WPL8 - Replacing Electric Passenger Compartment Heater (Workshop Campaign)

Revision: This bulletin replaces bulletin Group 8 136/23 WPL8, dated November 8, 2023.

Model Line: **Taycan (Y1A / Y1B / Y1C)**

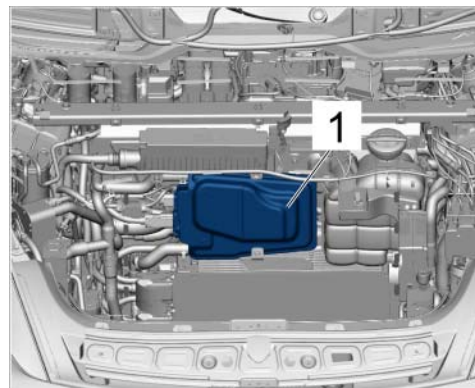
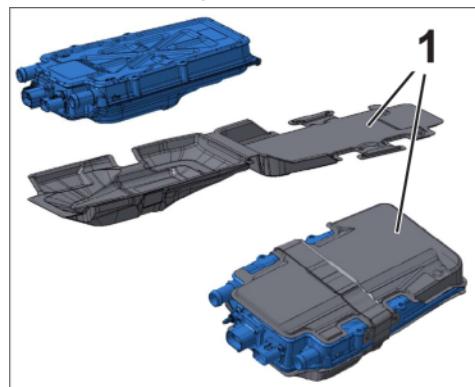
Please note that with only vehicles with the **auxiliary heater (M No. 9M3)** equipment option, is a thermal insulation (case) **also** ⇒ *Thermal insulation (case) -1-* installed on the electric passenger compartment heater. This must be converted from the old to the new electric passenger compartment heater.

Electric passenger compartment heater

Thermal insulation (case)
